# APPROVED\*

Project No. **19-0000653 (HDP)** Date: **04/22/2022**

\* NOTE: APPLICANT SHALL REVISE PLANS PER RESDLINES CONTAINED HEREIN PRIOR TO SUBMITTING BUILDING PERMIT APPLICATION.

**SERG PETROSIAN**  
 3425 BRACE CANYON RD, BURBANK CA 91504  
 COVER SHEET

**BRACE CANYON  
 SITE PLAN**  
 SCALE: 1/8"=1'-0"

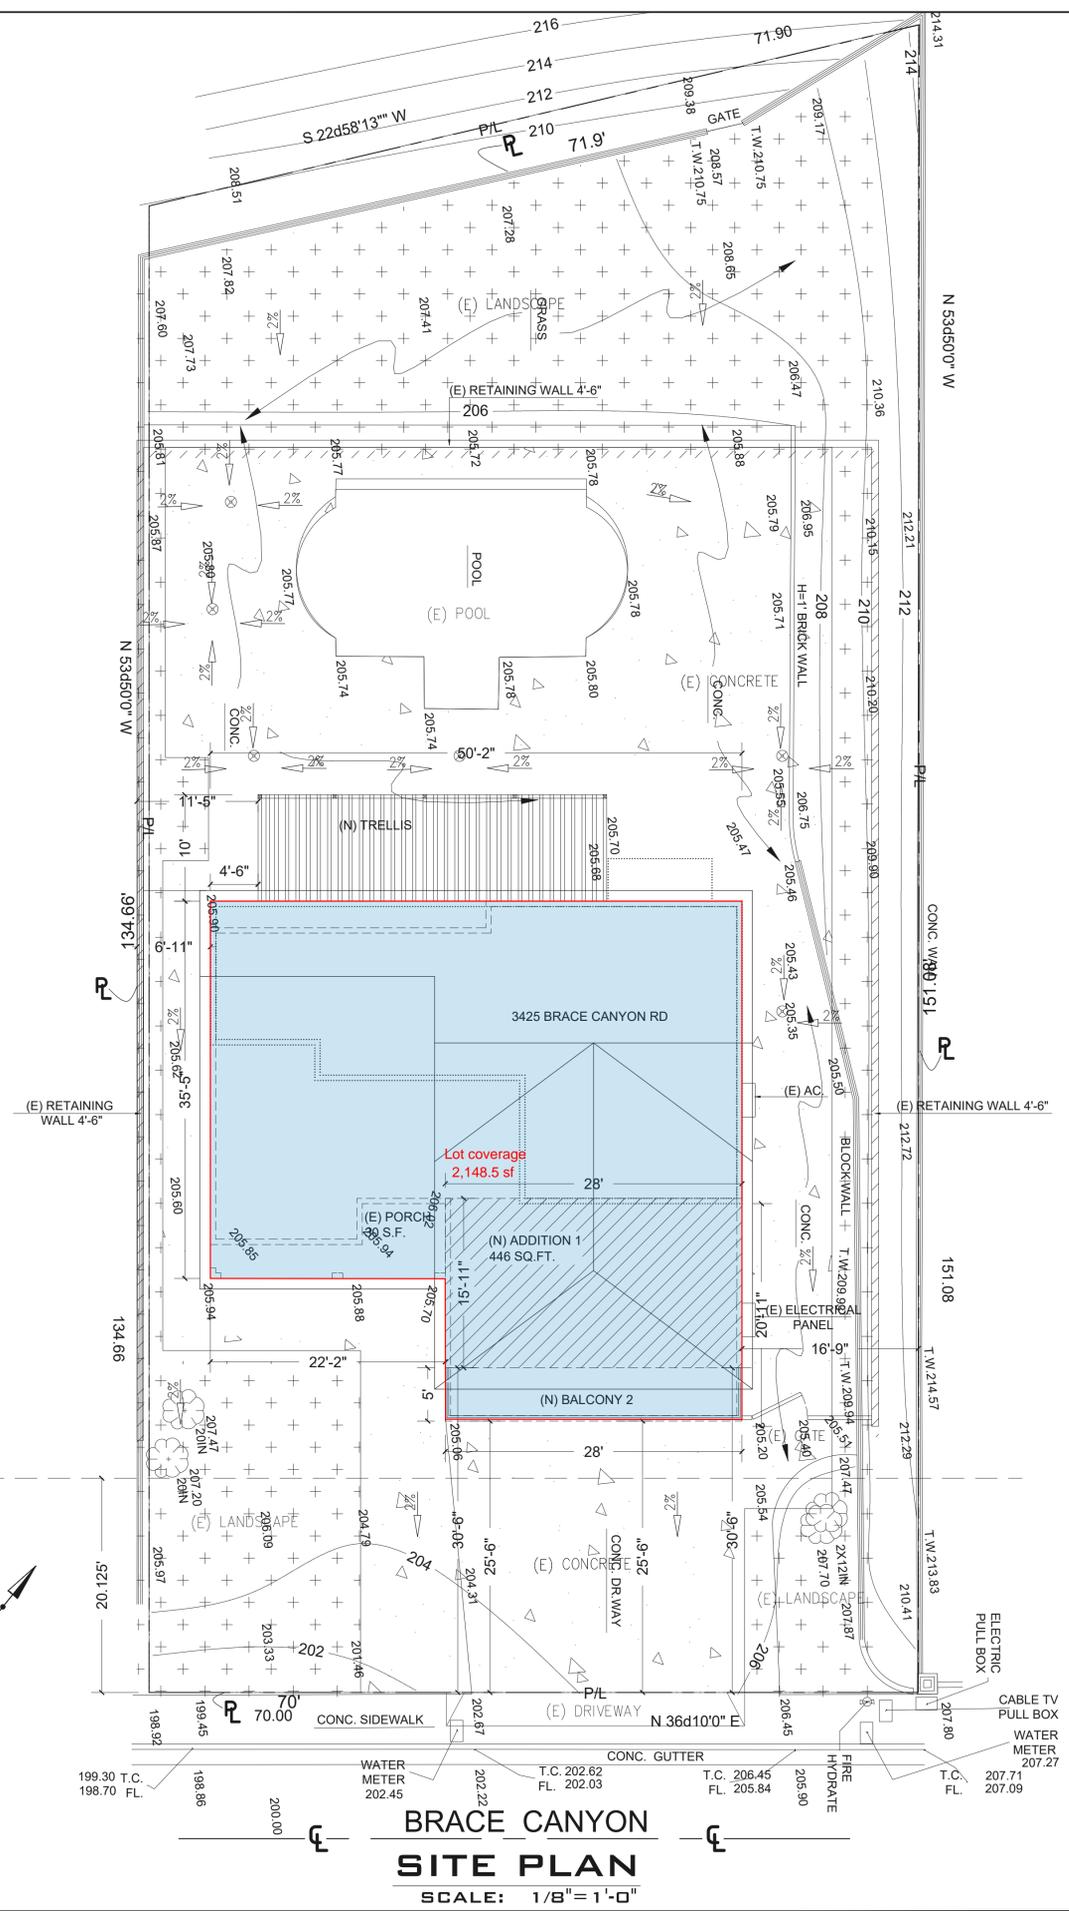
Lot coverage only counts for the "footprint" (see my comment to the right).  
 Lot Coverage = 2,148.5/10,005 =21.5%

**EXISTING & DEMO 1ST FLOOR PLAN**

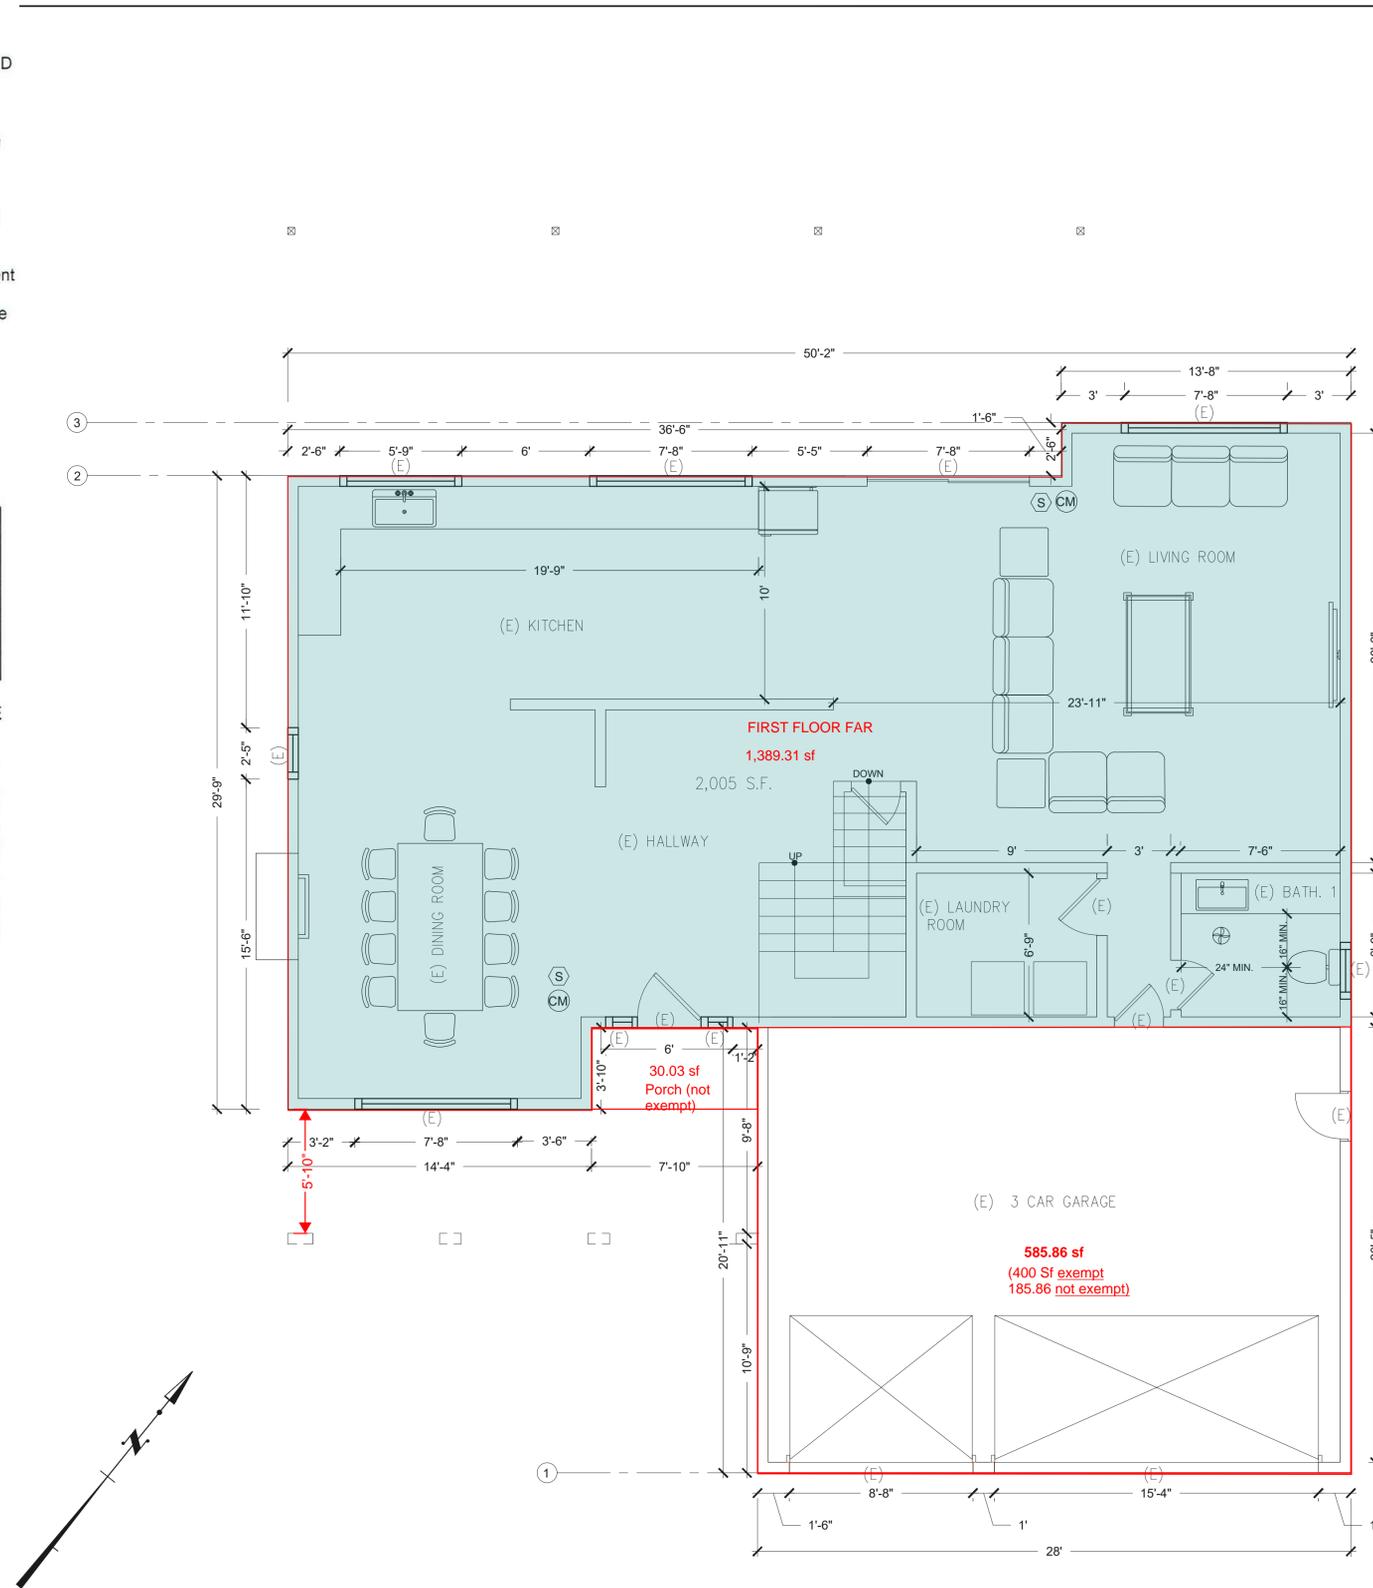
2,005 (1st Floor) - 400 (Exempt portion of garage) + 1,480 (2nd Floor) = 3,085 S.F.

**PROPOSED 1ST FLOOR PLAN**  
SCALE: 1/4" = 1'-0"

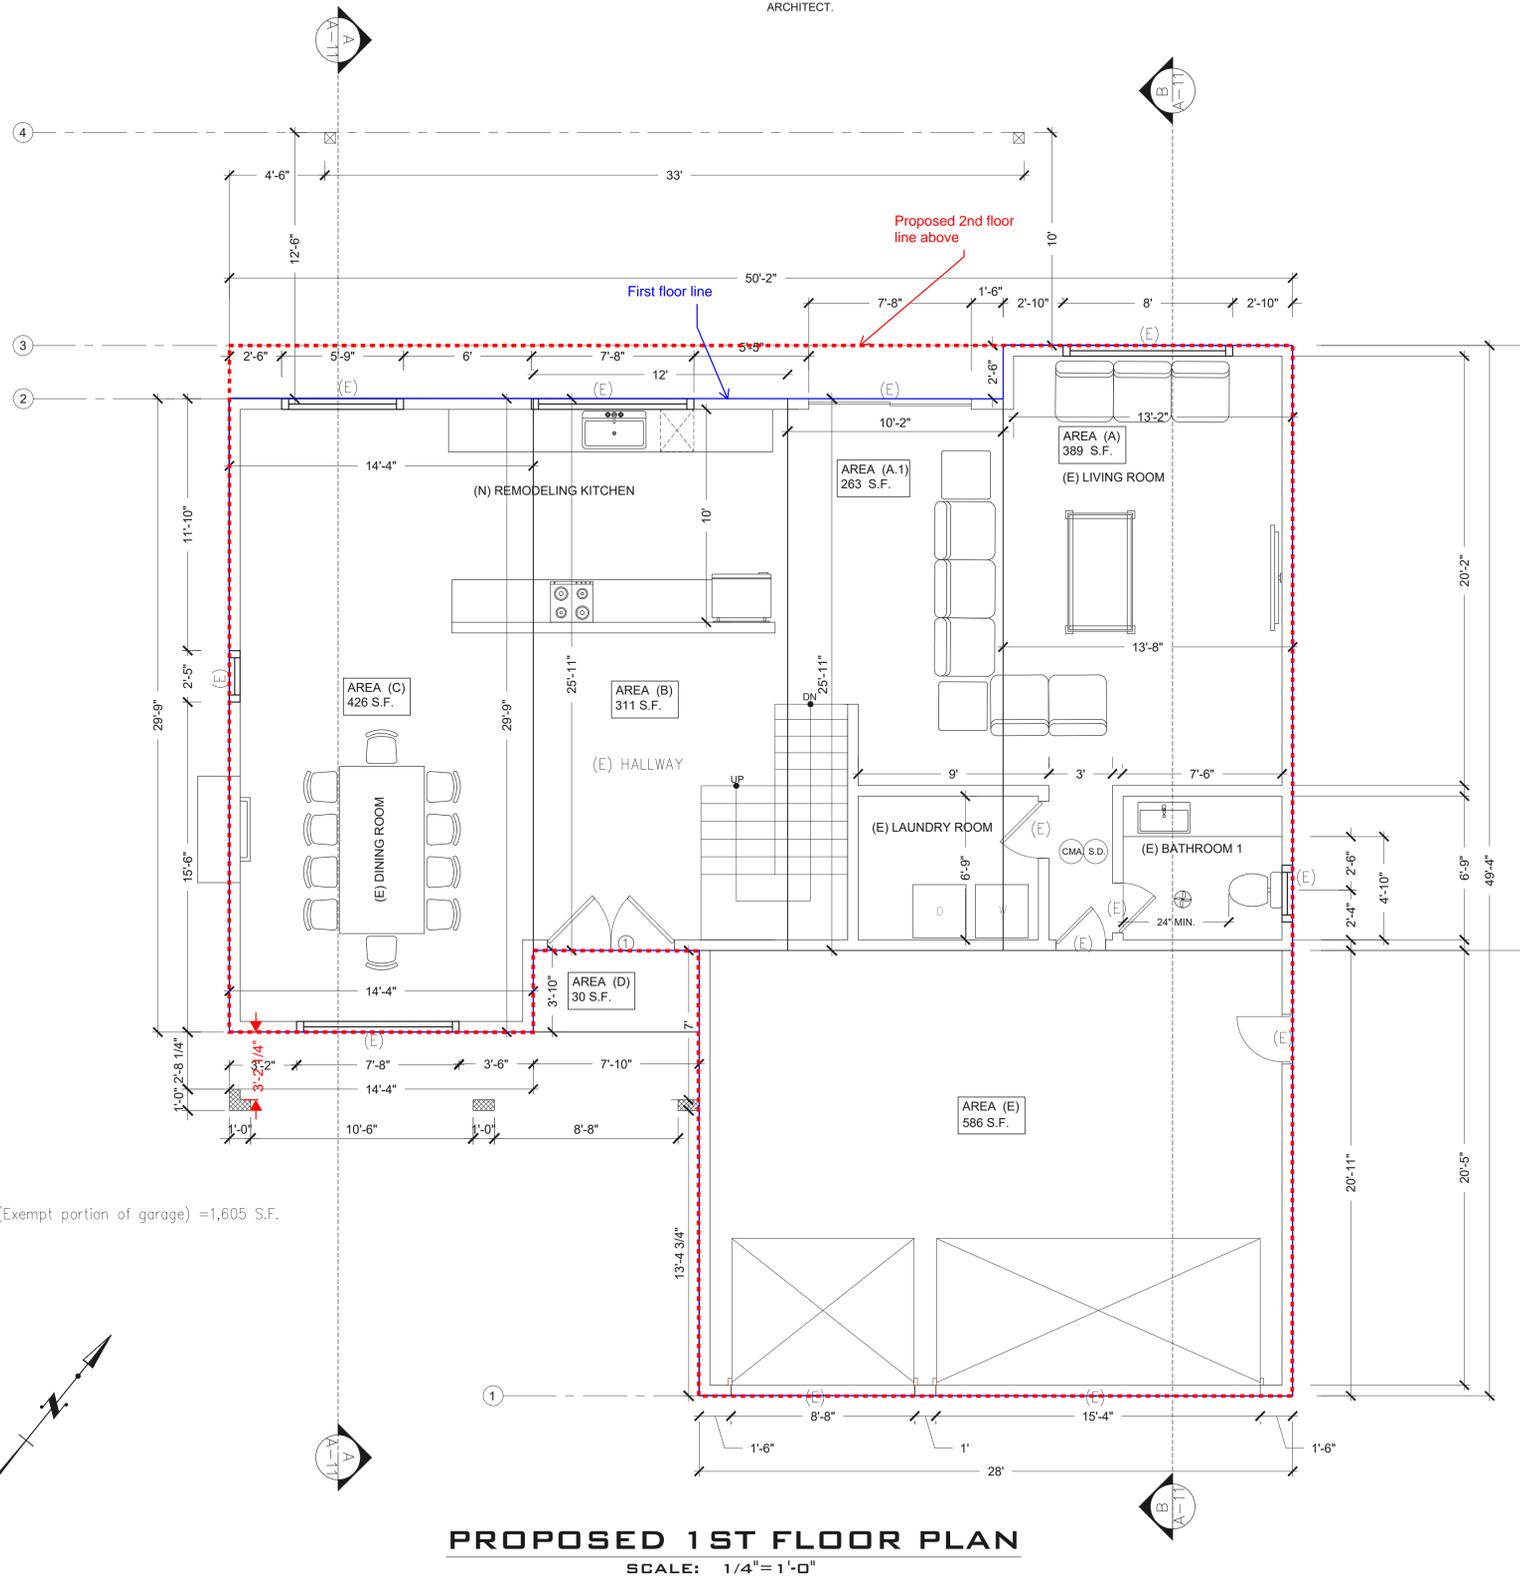
2,005-400(Exempt portion of garage) = 1,605 S.F.

**PROPOSED 2ND FLOOR PLAN**

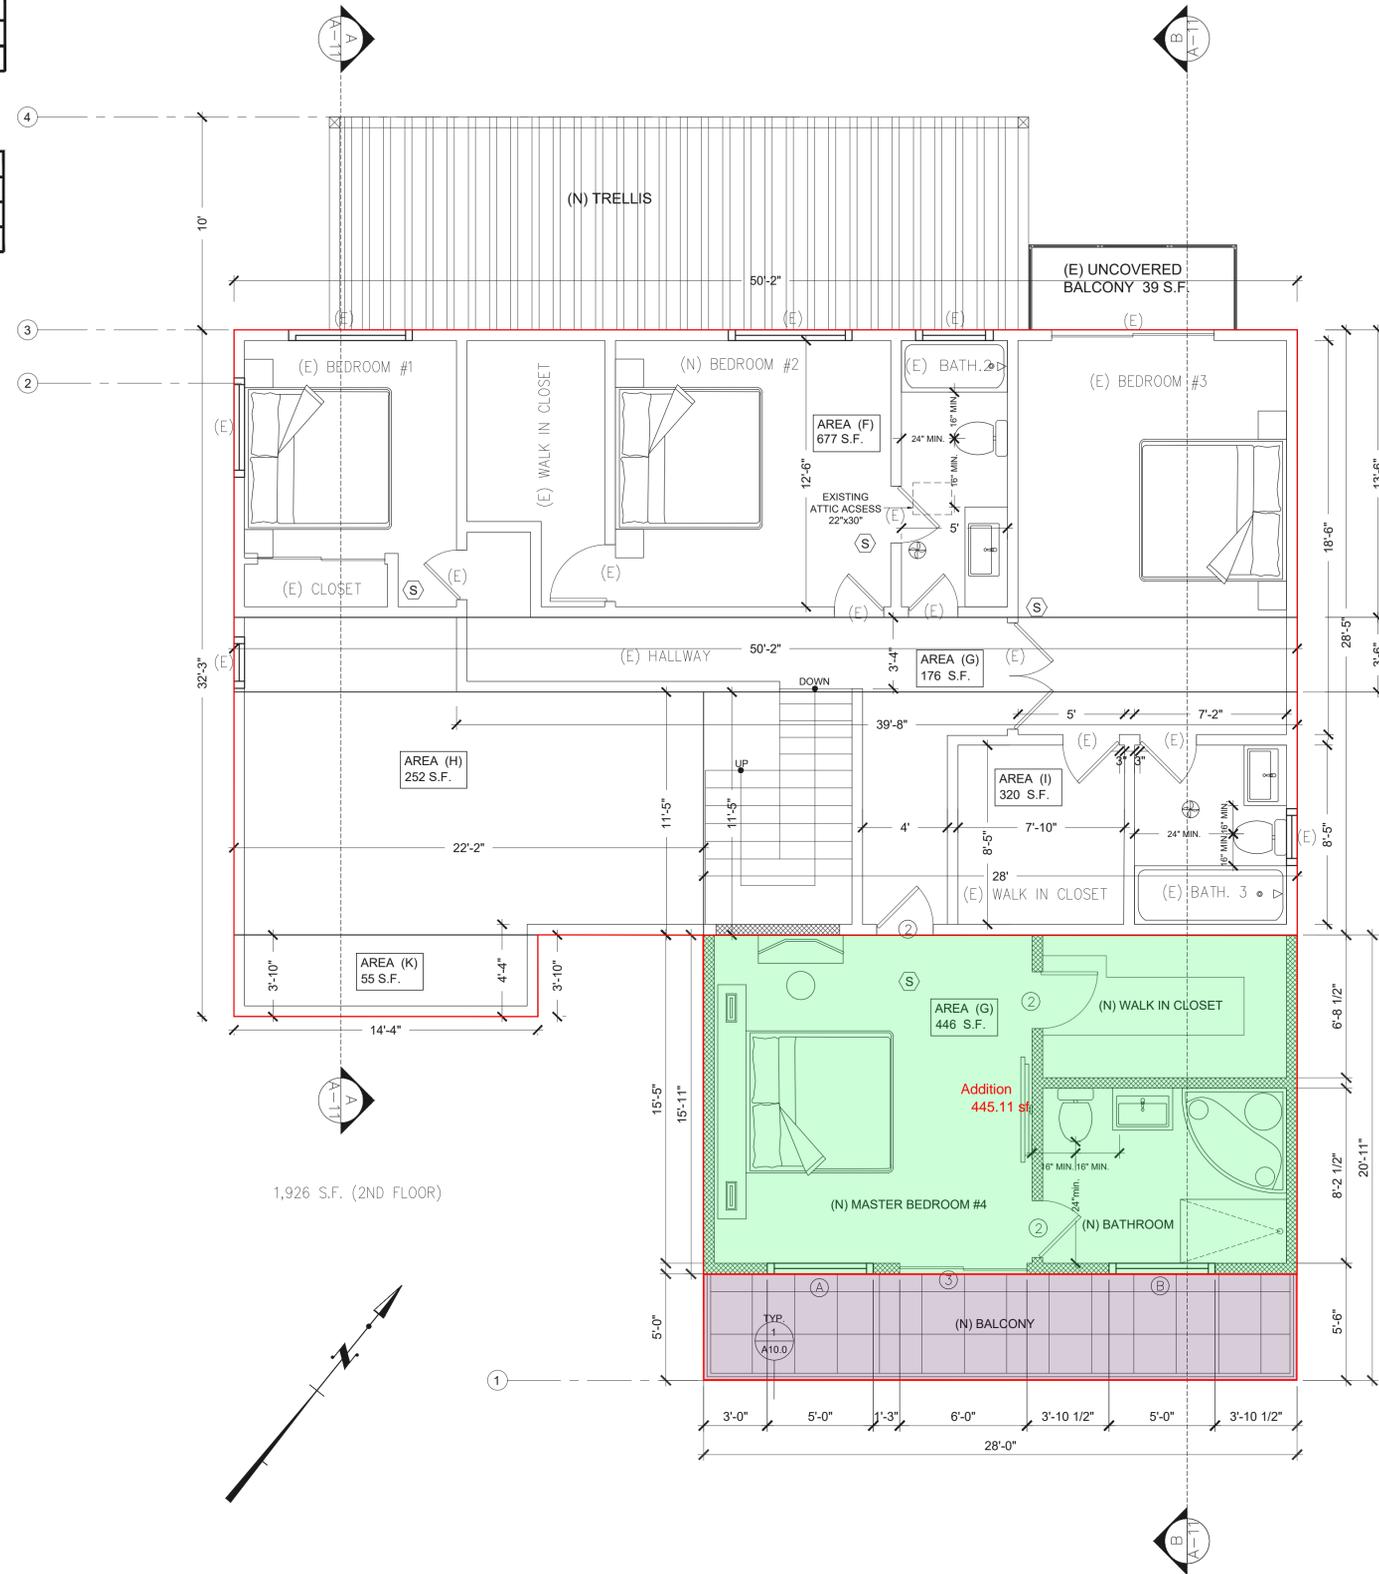
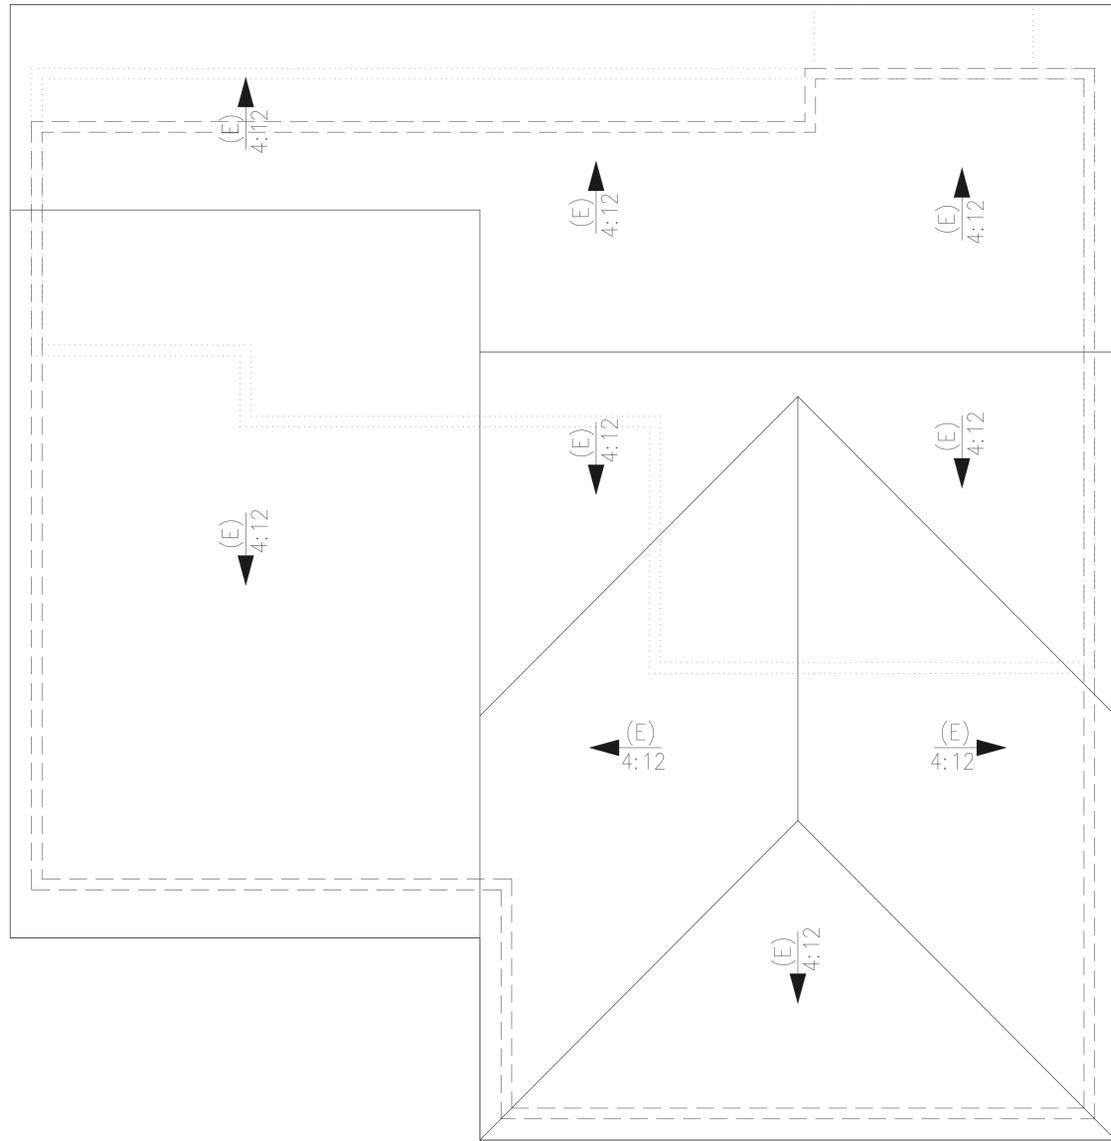
1,926 S.F. (2ND FLOOR)
